V-24-04	Staff Report – May 16, 2024					
Application Type:	Area Variance					
Summary of Proposed Action:	Applicant is seeking relief, in regarding to the standards of MX-4 Zone District, to establish a “multi-story building wall sign” on the north elevation of a multi-unit dwelling apartment, named “The CODA”. The proposed sign will exceed the maximum allowed sign face height.					
Project Address:	301 South Crouse Avenue & East Genesee St (Tax Map ID: 048.-05-04.3)					
Owner/Applicant	TLSP CODA LLC (Owner) James Trasher, CHA Consulting Inc. (Applicant)					
Zoning Violations	<p>The proposed project is seeking an area variance from the Board of Zoning Appeals to violate the following Zoning Ordinances:</p> <ol style="list-style-type: none"> ReZone, Art. 4, Sec. 4.8H(2), Sign regulations for MX-4 Zone District. – Maximum sign face height for Multi-story Building Wall Sign is 10 FT. <table border="1" style="width: 100%; border-collapse: collapse;"> <thead> <tr> <th style="text-align: center;">Allowed in Zoning Code</th> <th style="text-align: center;">Proposed by Applicant</th> </tr> </thead> <tbody> <tr> <td style="text-align: center;">Maximum sign face height: 10 FT</td> <td styl

3 NORTH ELEVATION (EAST FAYETTE STREET)
A.02 SCALE: 1/16" = 1' - 0"

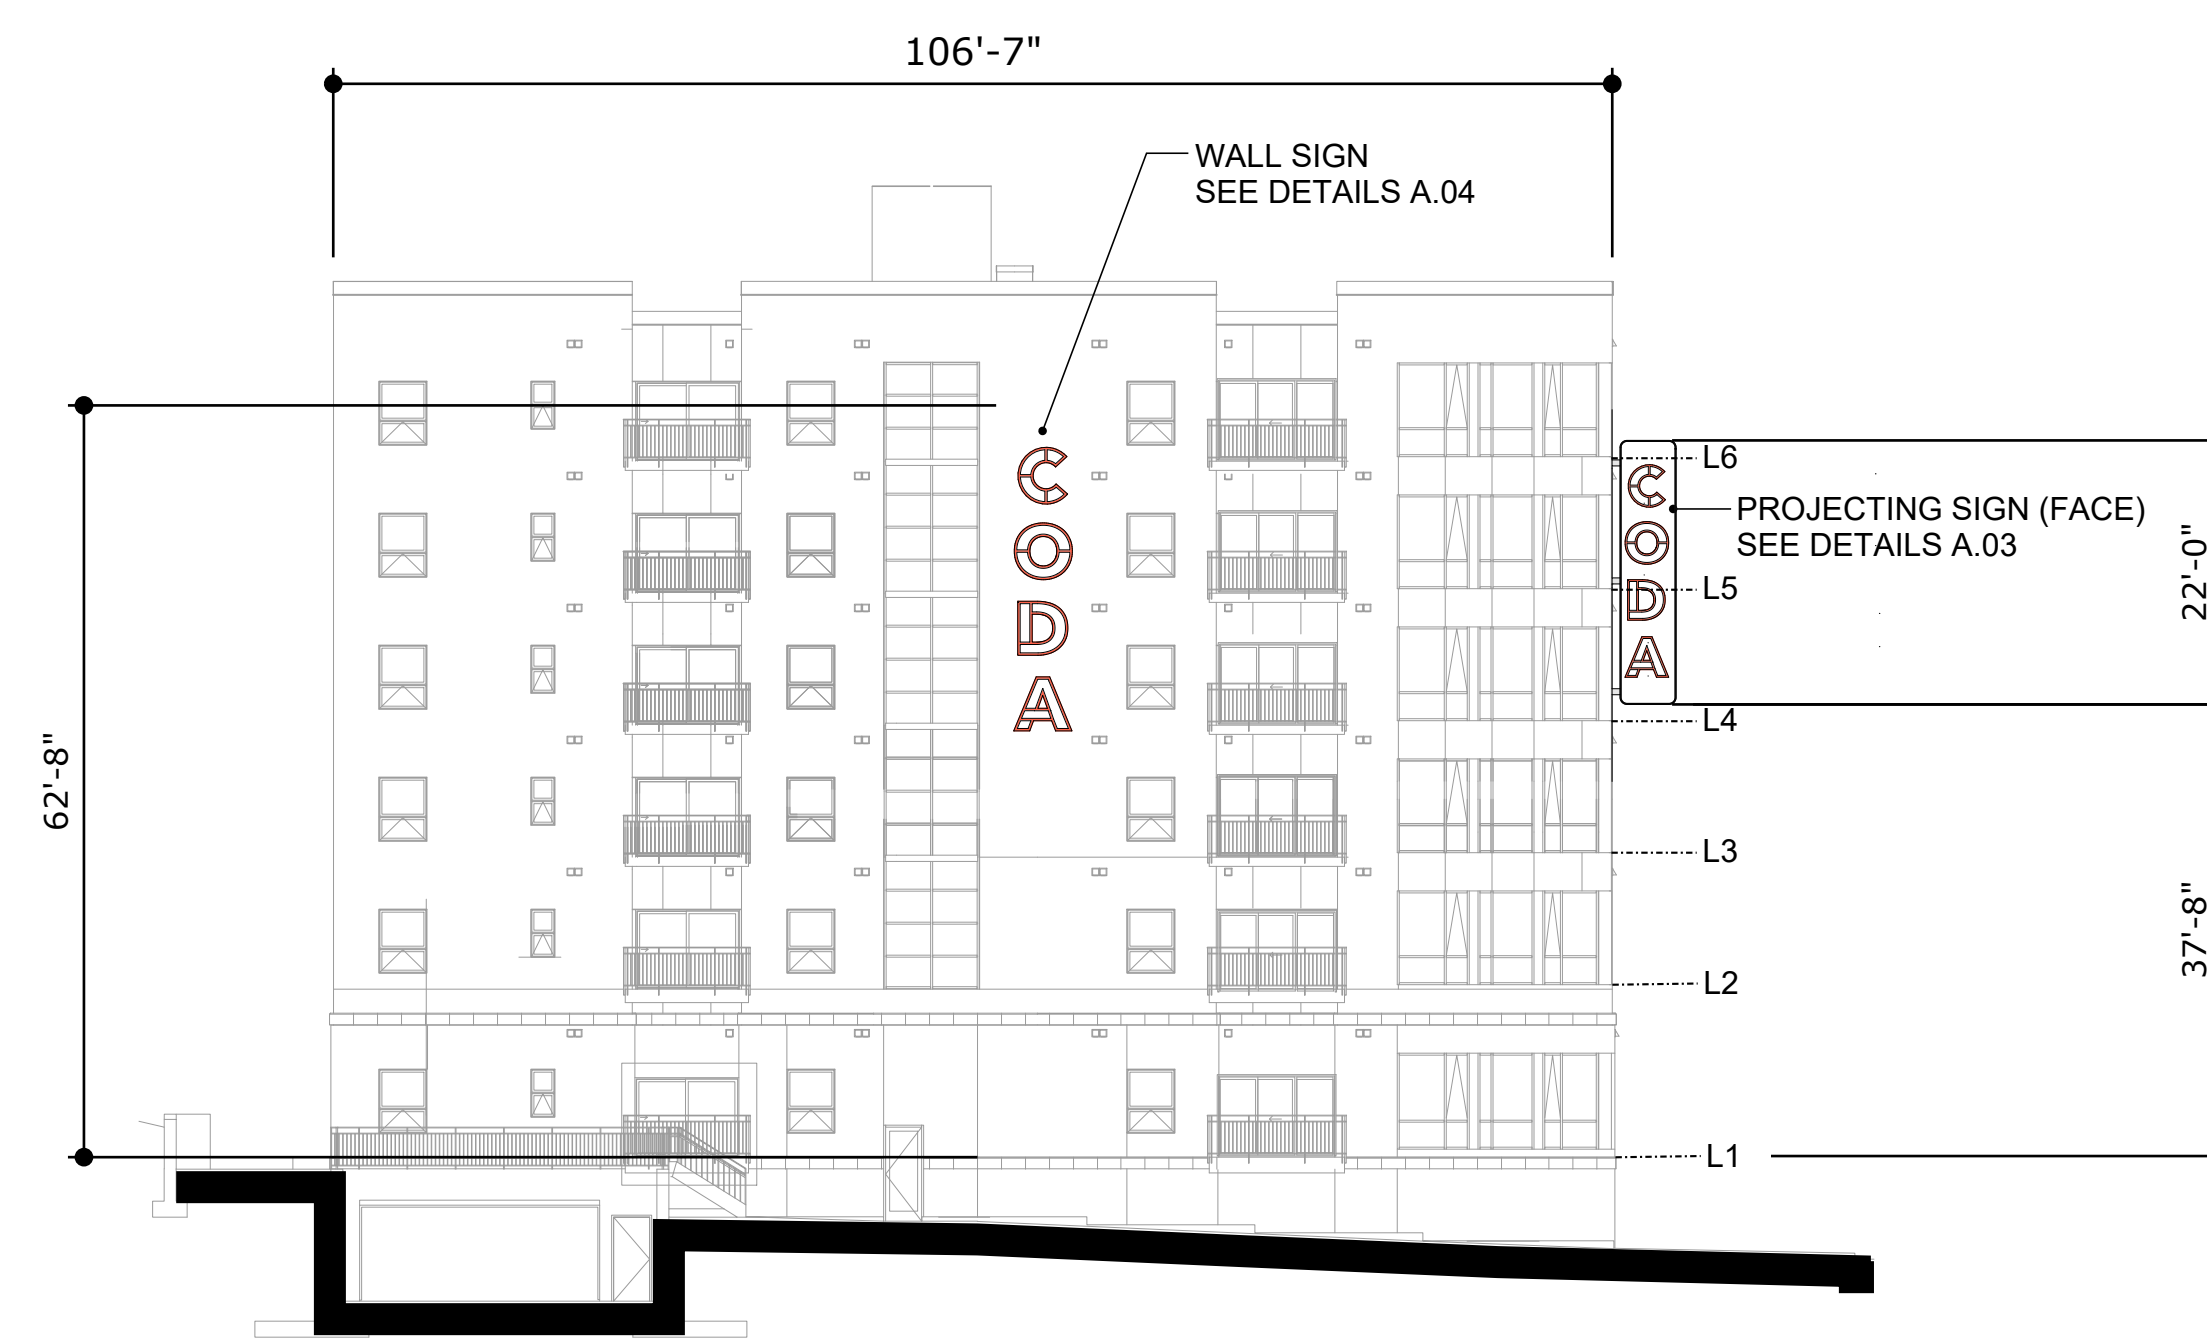
- Sign 1 Wall Sign North Elevation
 - Allowed 10 ft maximum height
 - Requested variance to allow a height of 23’-7” due to the vertical orientation

1
A.04 WALL MOUNTED SIGN DETAIL
SCALE: 1/2" = 1' - 0"

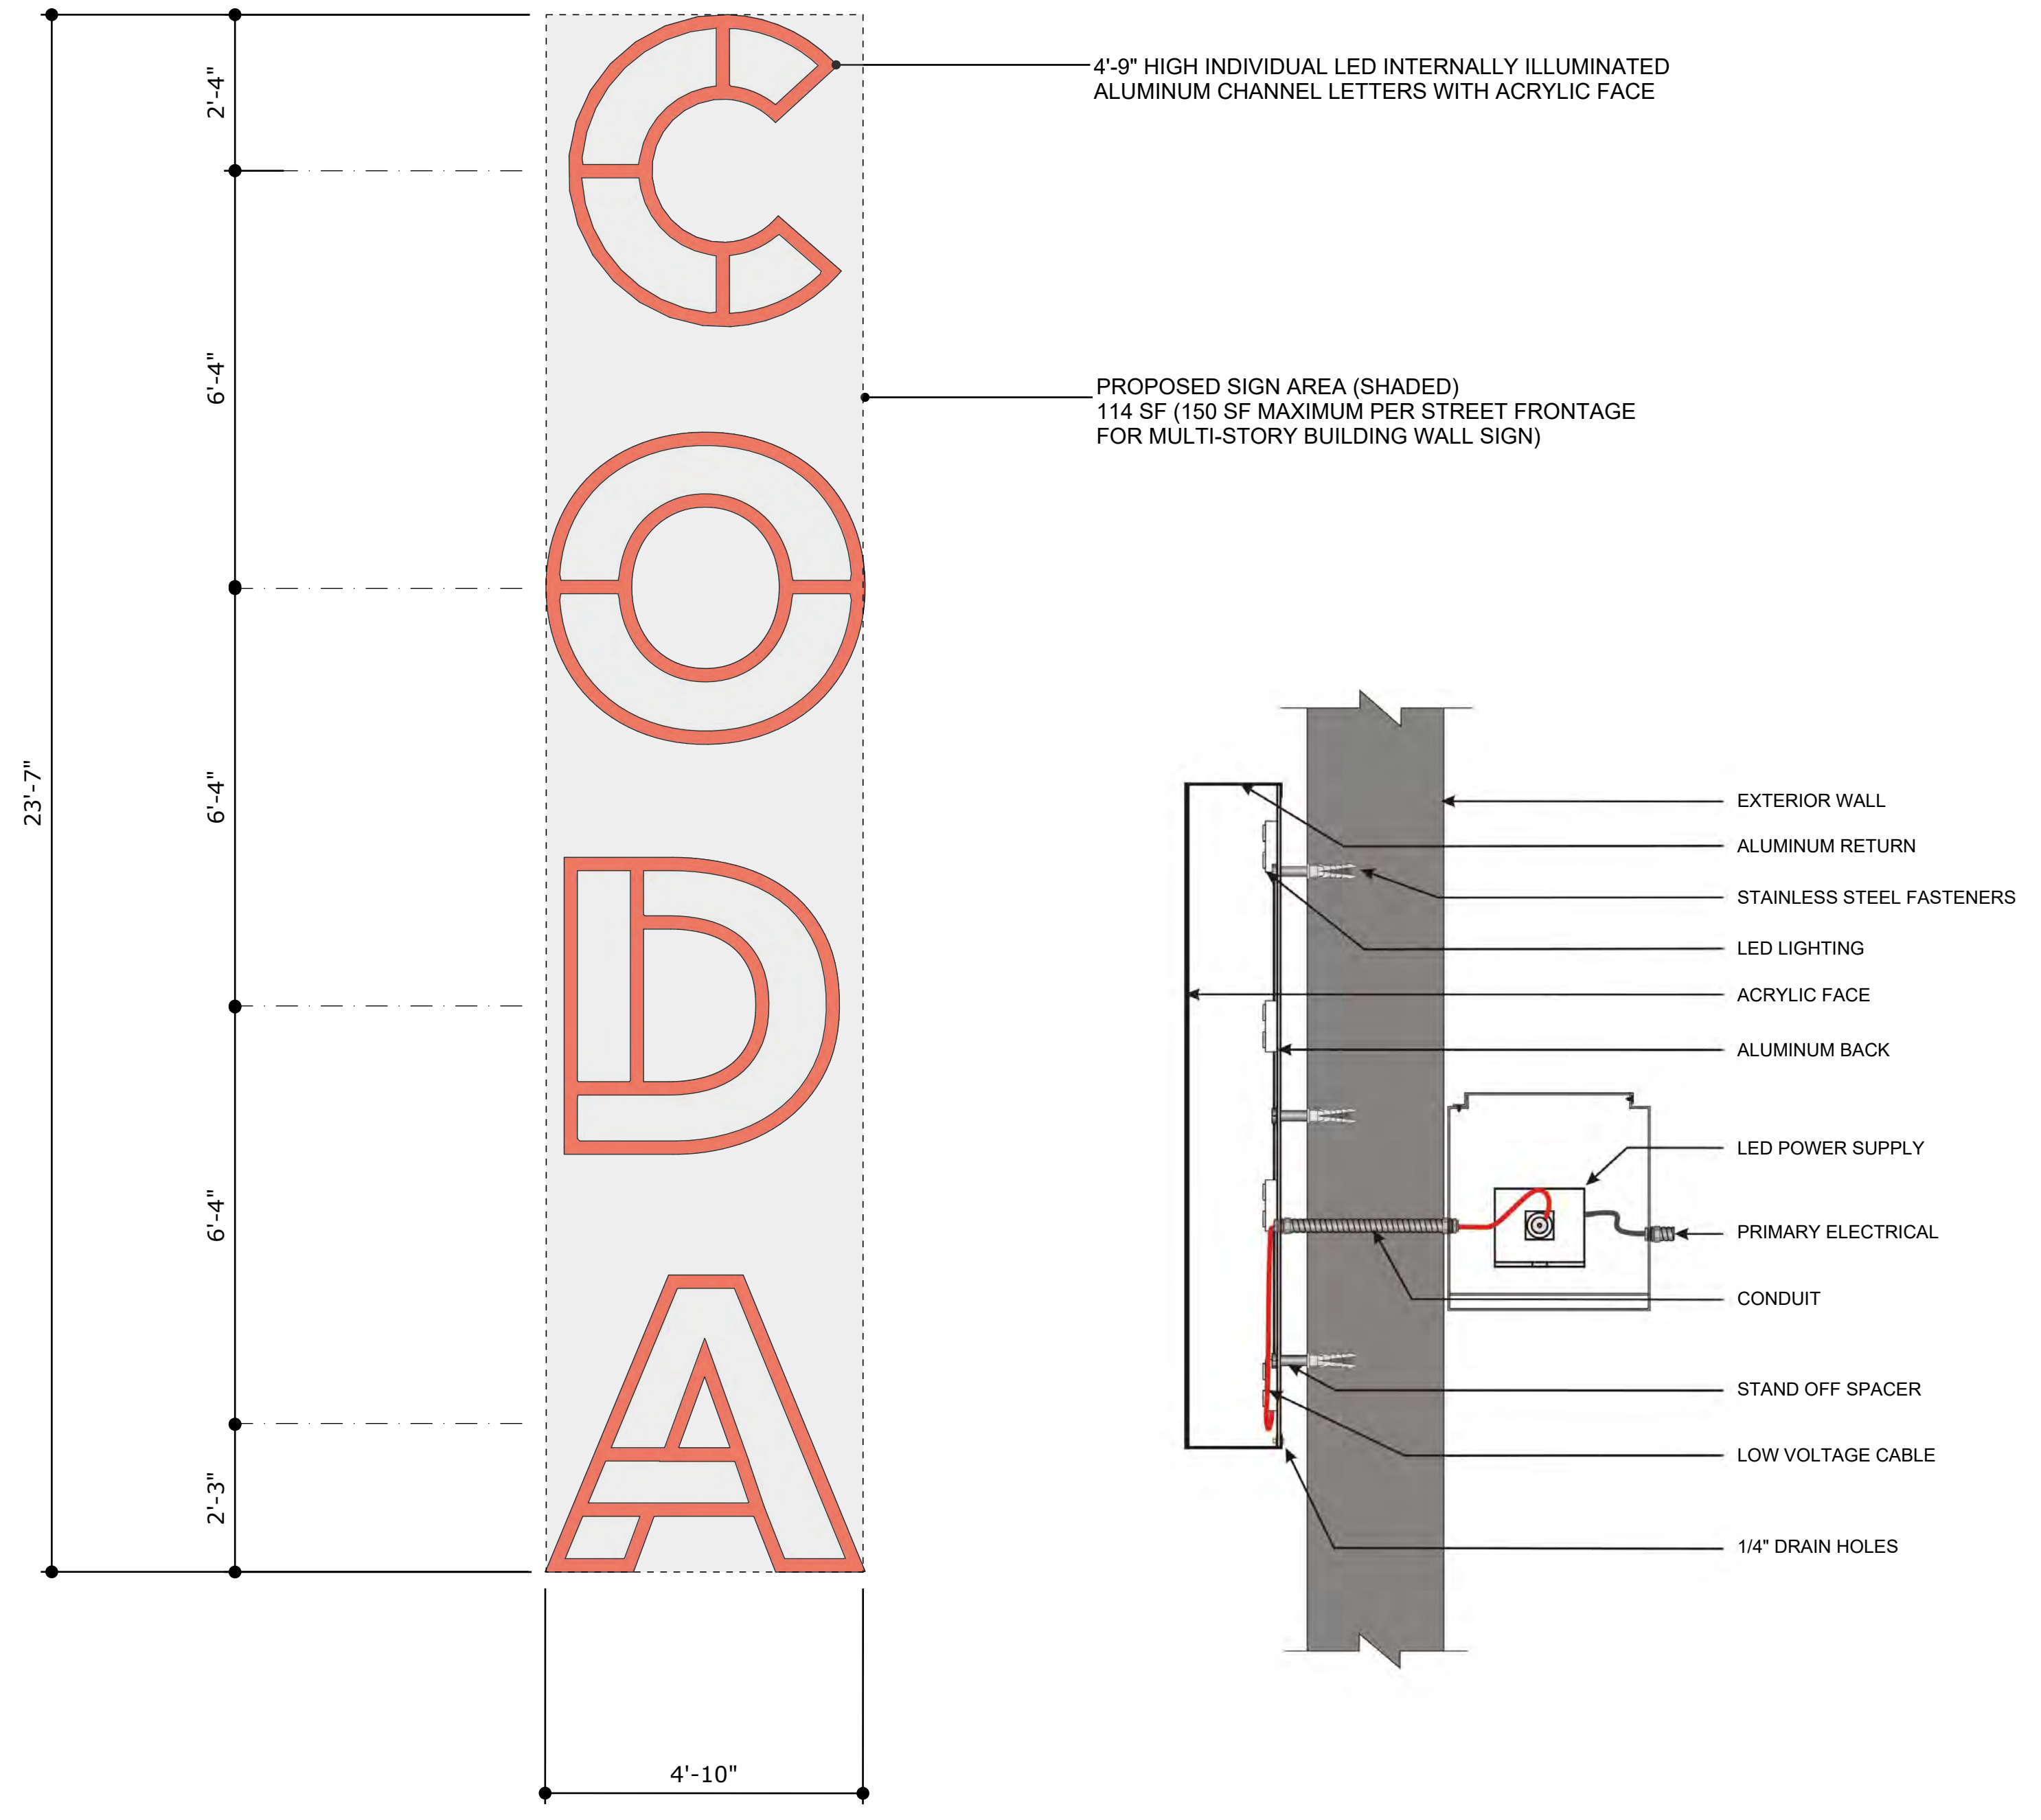
The Board generally discourages allowances for such substantial signage variances, which can dominate the façade of the building and detract from desired community character.

Approval	Status	Status Date	Reviewer	Comments
Board of Zoning Appeals	Pending	03/18/2024		
Zoning Planner	On Hold	04/18/2024	Zhitong Wu	On hold for approval from BZA.
Landmark Preservation Board	Internal Review Complete	05/10/2024	Kate Auwaerter	The SLPB reviewed the application materials at its 5/9/24 meeting. The SLPB determined that the wall sign facing E. Fayette Street ("Sign 1") would have no impact on historic resources.
